FINAL BRIDGING DECISIONS AND ALIGNMENT REVIEW

STIP Project I-4400/I-4700

North Carolina Department of Transportation

MERGER CONCURRENCE POINT 2A

Site 4

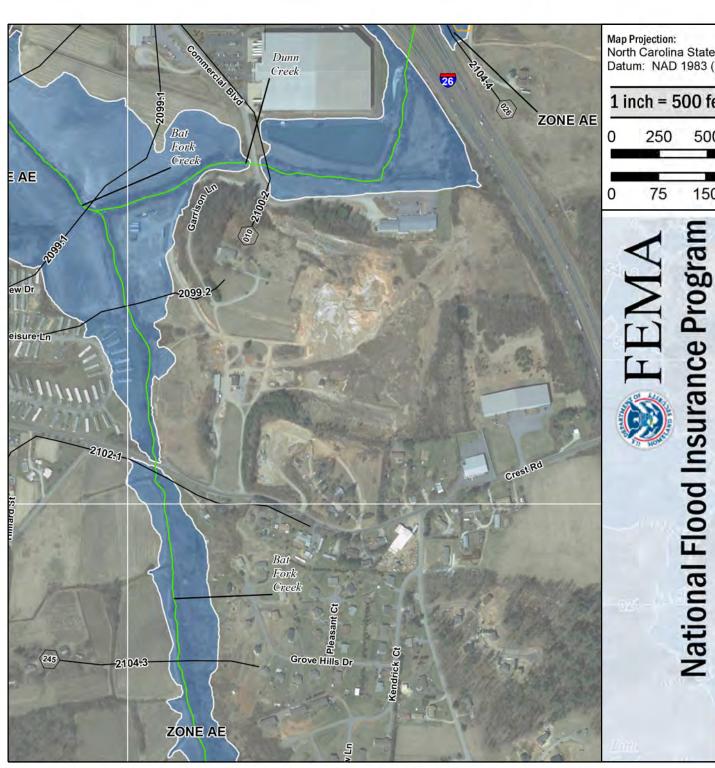
Site 4 – Marella identified this crossing as a candidate for a bridge since a supplemental pipe was recommended for all alternatives.

- HNTB advised that Dunn Creek is a FEMA regulated stream and would need to meet FEMA backwater criteria.
- HNTB added that with a drainage area of 2.58sq. mi., this crossing would generally not be considered for a bridge crossing.

The Merger Team agreed with the recommendations identified in the table included in the Merger Project Team Agreement Signature Form, except it was requested that for the 8-lane Alternative, bridges be evaluated for Sites 4 and 7. As such, the signature form was revised to include *Evaluate bridges at Sites 4 and 7 for the 8-lane Alternative.

Site 7

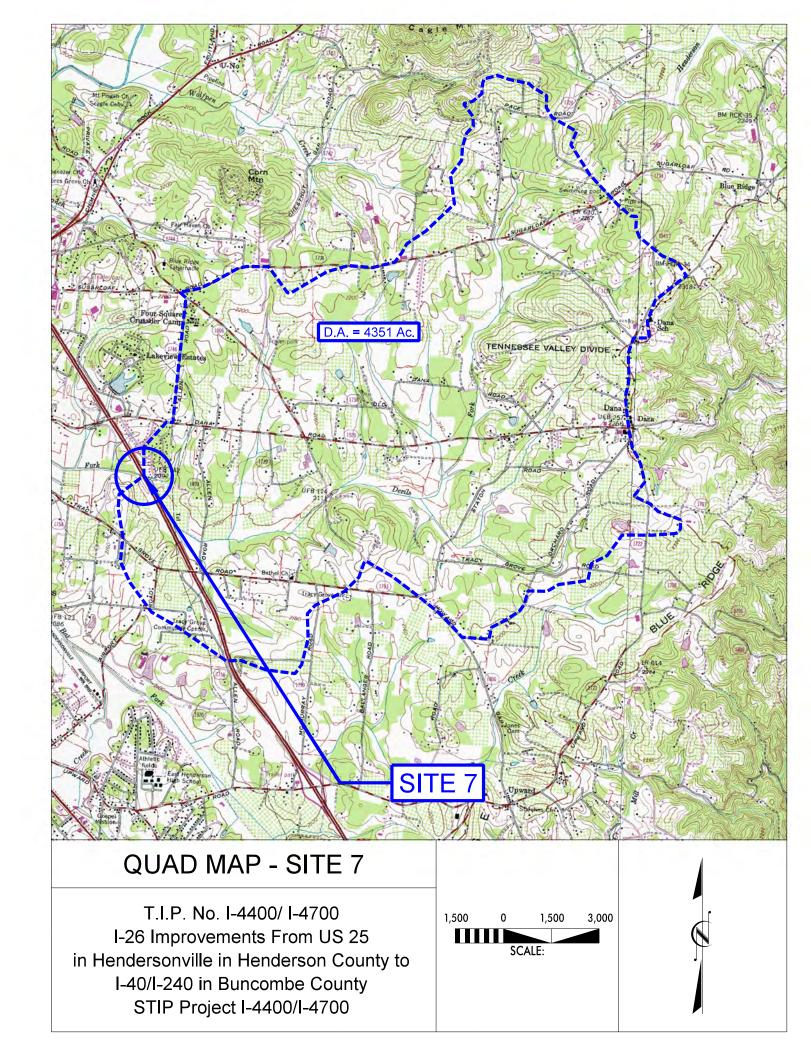
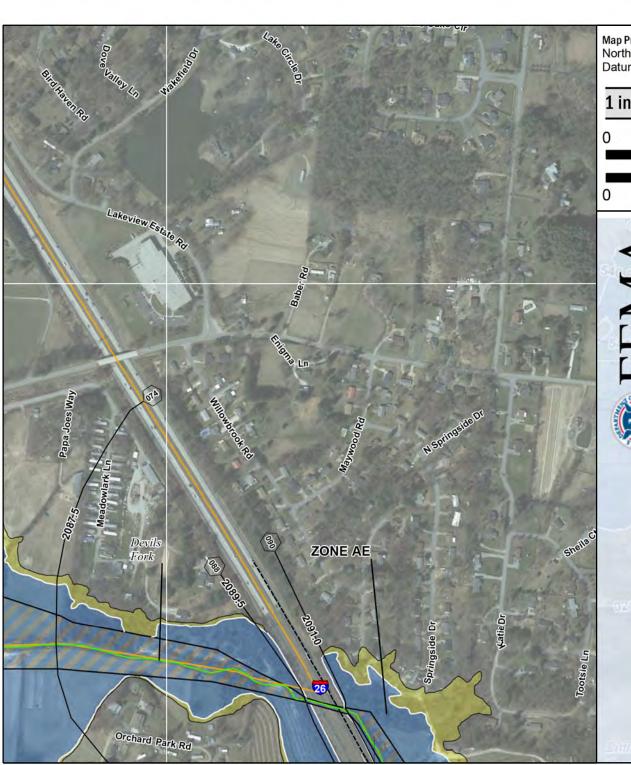
Site 7 – Marella and Marla identified this crossing as a candidate for a bridge since it is a 3-cell box culvert with some internal cracks and over widening of the channel at the inlet.

- HNTB advised that Devils Fork is a FEMA regulated stream and would need to meet FEMA backwater criteria.
- HNTB added that with a drainage area of 6.8sq. mi., this crossing may be considered for a bridge crossing for new location design, but does not recommend a bridge for an existing facility.
- For preliminary design of the Preferred Alternative, HNTB will review the Inspection Report for the crossing.
